NUEVO ATRISCO | MAJOR SITE PLAN AMENDMENT DRB COMMENT RESPONSES

NUEVO ATRISCO DRB Comment 6.24.2022 Responses					
Commenting Agency	Action	Date Received	Comment	Applicant Response	Applicable sheets
NMDOT	PR-2018-001405 Site Plan PR-2020-003847 Plat	6.24.2022	NMDOT does not have any comments at this time	No response necessary	-
AMAFCA	PR-2020-003847 Plat	6.24.2022	No adverse comments	No response necessary	-
MRMPO	PR-2018-001405 Site Plan	6.24.2022	MRMPO has no adverse comments	No response necessary	-
	PR-2020-003847 Plat	6.24.2022	MRMPO has no adverse comments.	No response necessary	-
ABCWUA	PR-2018-001405 Site Plan	6.24.2022	Availability Statement #211219 has been issued and provides the conditions for service. The availability statement indicated a fire flow of 1,725 gpm whereas the provided fire one plan in the DRB submittal indicated a fire flow of 2,000 gpm. Please confirm. A new request for availability may be required to account for the increase in fire flow.	Civil is coordinating with ABCWUA and has submitted a new water availability statement

PR-2018-001405 Case Description: Amendment to Site Plan | SD-2022-01115, VA-2022-00165 Sidewalk Wavier | PR-2020-003847 Case Descr

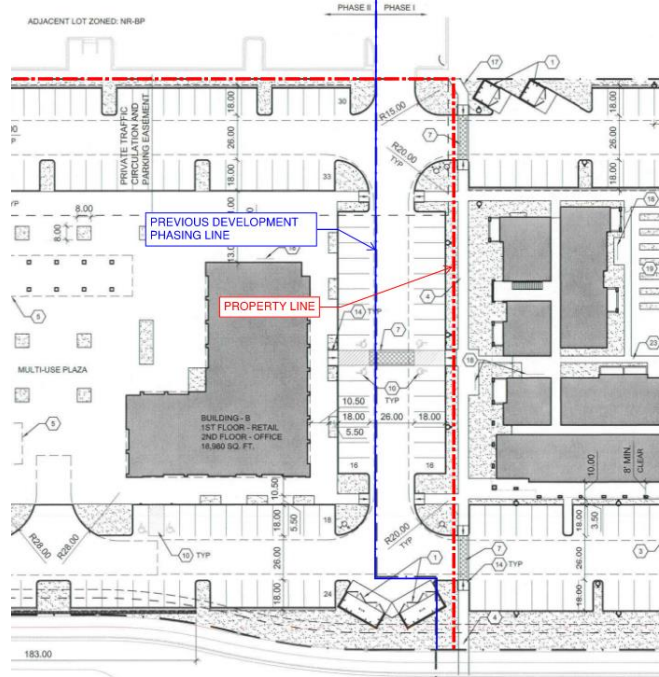
Commenting Agency	Action	Date Received	Comment	Applicant Response	Applicable sheets
Planning	PR-2018-001405 Site Plan	6.24.2022	<p>Confirm compliance with 5-1(D)(2)(b)(2) along the north property line: “A 3-foot wall and trees spaced 20 feet on center shall be required between any outdoor seating and gathering area or outdoor dining area and a parking or loading area.”</p> 	<p>The site plan complies with Section 5-1(D)(2)(b) that requires 50% of the front property line to be occupied by a building. 185’ of the 313.88 linear feet of property line is occupied by a building equating to 58%.</p> <p>The property line is now located directly adjacent to the sidewalk of the adjacent multi-family site and the community building and associated outdoor amenities occupy the location that was once a drive-aisle and parking indicated below. The outdoor spaces associated with the community building therefore do not front parking areas and the buffering requirements of 5-1(D)(2)(b)2 are not applicable, see diagram to the left.</p>
